Development Application – 76 Central Avenue and 62-68 Central Avenue Oran Park - (DA 2019/269/1)

Attachment A

North South Rail Line (South of Oran Park Station Box)

Commercial Building 2 - Peter Brock Drive, Oran Park

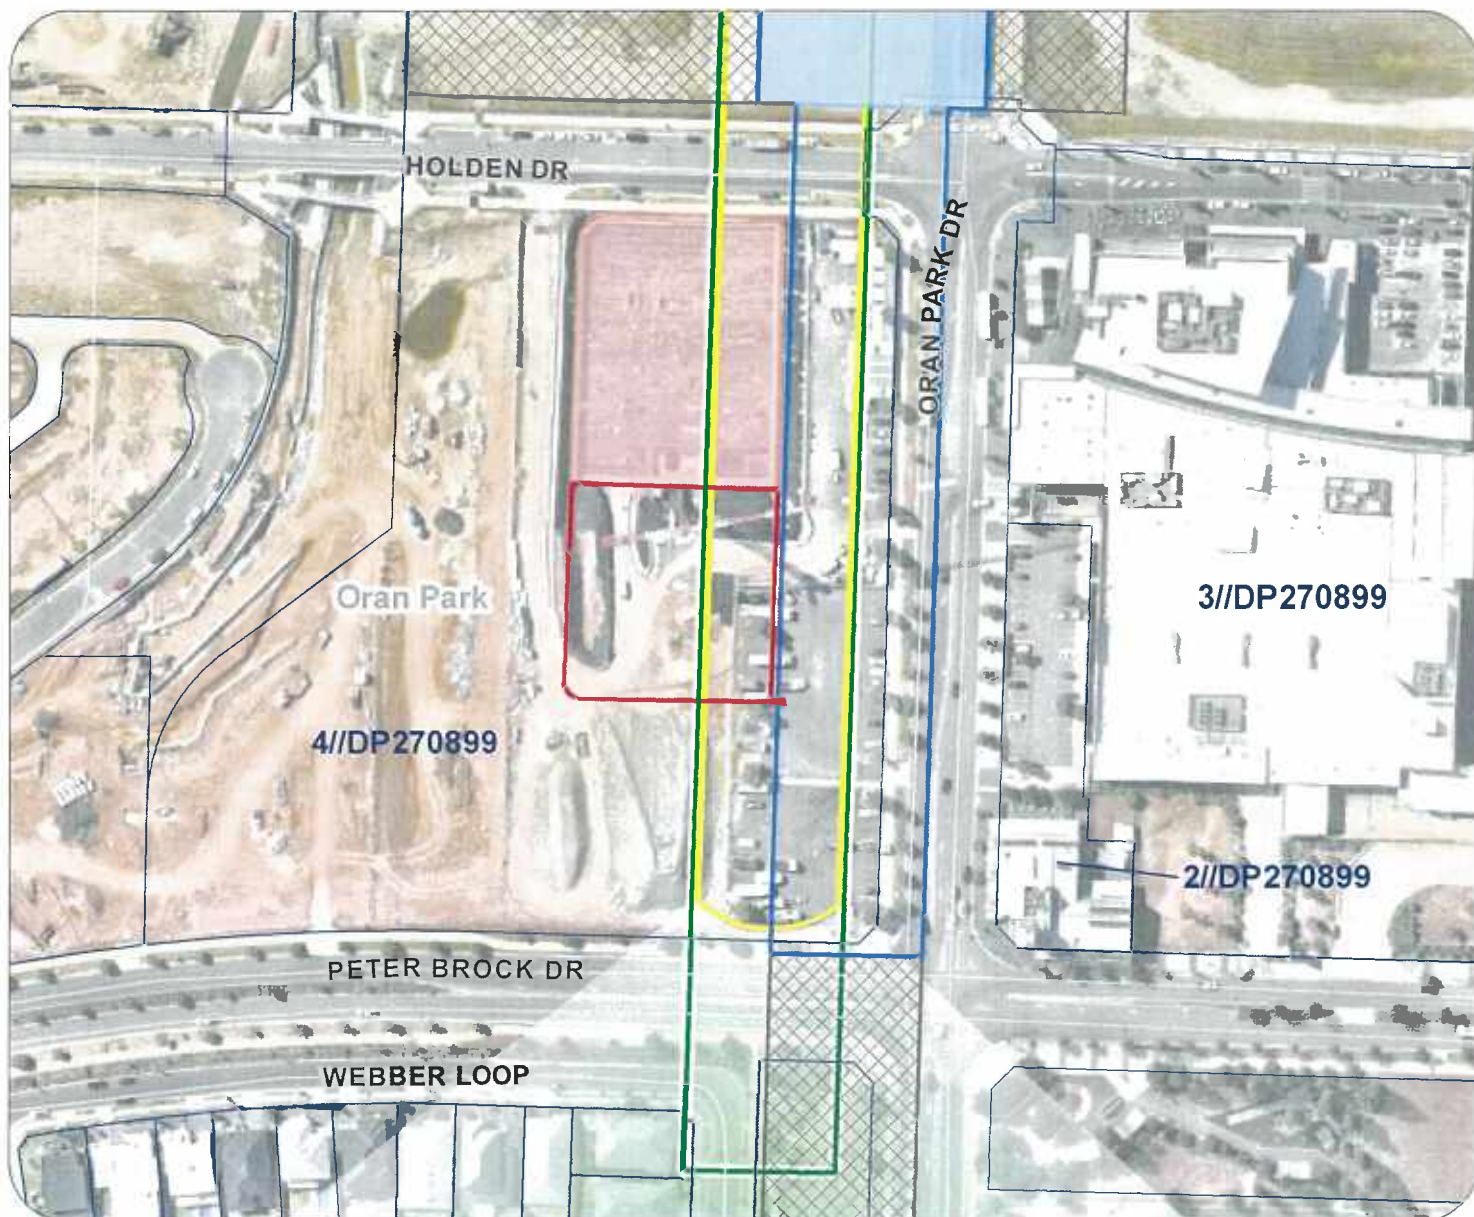
- No rock anchors, rock bolts, ground anchors or rock ties, piles, foundations, rock pillars, transfer structures, basement walls, slabs, columns, beams, cut rock faces, are to be installed in the proposed NSRL corridor. The Certifier must not issue a Construction Certificate for the development until written confirmation has been received from TfNSW that this condition has been satisfied.

- Any piles must be at least 1m from the wall of a tunnel or cutting and be debonded from the rock interface where above the rail formation level unless the piles are outside a line drawn at 1V/1H from the edge of the track formation;

- No rock anchors, rock bolts, ground anchors or rock ties, piles, foundations, rock pillars, transfer structures, basement walls, slabs, columns, beams, cut rock faces, are to be installed in the future rail corridor, property or easements. The Certifier must not issue a Construction Certificate for the development until written confirmation has been received from TfNSW that this condition has been satisfied.
- Permanent anchors are not allowed in the support of the basement; and
- The basement wall must not be closer to the railway corridor than the depth to which it retains soil.
